# Service Letter

## Service Letter No. 432 March, 1995

**SUBJECT: Product Updates**

**MODELS AFFECTED: 404D and 411**

#### **Model 404D Internal Oil Supply**

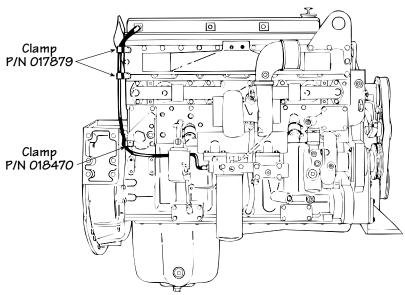
The Straight Adapter (P/N 018685), used with the Internal Oil Supply Hose Assembly (P/N 018686), replaces the  $90^{\circ}$  Adapter (P/N 017185). This change allows for easier installation of the hose. The Straight Adapter (P/N 018685) should be tightened to a torque of 150 lb.-in. (17 N $\bullet$ m).

The 90° Adapter, P/N 017185, can only be used with the Hose, P/N 017183. The adapter (P/N 017185) and hose (P/N 017183) is discontinued for L10 application.
